LAND - ROVER

Vol. 2 Issue 3

NUMERICAL INDEX TO SERVICE INFORMATION — Vol. 2 Issue Nos. 1 to 3

Subject: Reverse gear 'jump-out'

ITEM 5

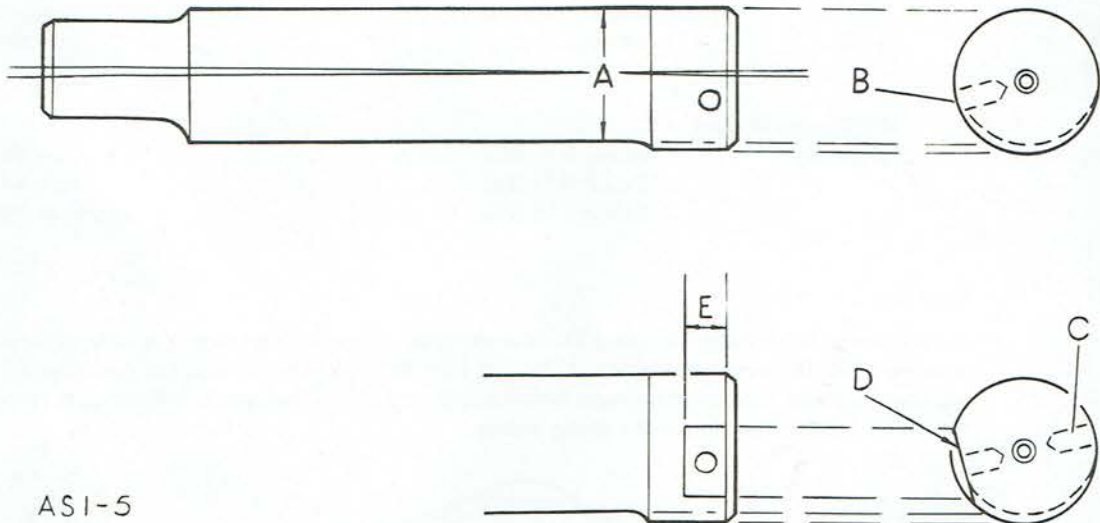
The outside diameter of the gearbox idler shaft (A) is deliberately machined at an offset angle to assist reverse gear retention under arduous operating conditions. It is correctly located in the gearbox by a cross-drilled hole (B) which is engaged by a spring dowel, part number 591519.

If reverse gear jump-out is experienced with gearbox numbers prior to 90208170A, 24600273A, 95109042A, 94110746A or 26600408A, it is possible this is due to incorrect location of the offset idler shaft caused by the cross-drilling being 180° out of position, see C.

Where a correctly drilled shaft part number 591527 is not available the original shaft can be easily modified as follows:—

1. Remove the spring dowel from the incorrect hole in the idler shaft.
2. Grind a flat (D) 0.04in (1mm) deep on the shaft at 180° to the existing incorrect hole, to remove the case hardening.

NOTE: The flat area (E) must not extend completely across the length of the concentric finished diameter.

3. Drill a hole 0.157in (4mm) dia., 0.210in-0.230in (5.3-5.8mm) deep, 0.200 ± 0.01 in (5.08 ± 0.25 mm) from the end of the shaft and at 180° to the existing hole.
4. Re-assemble using the new cross-drilling for the spring location dowel.
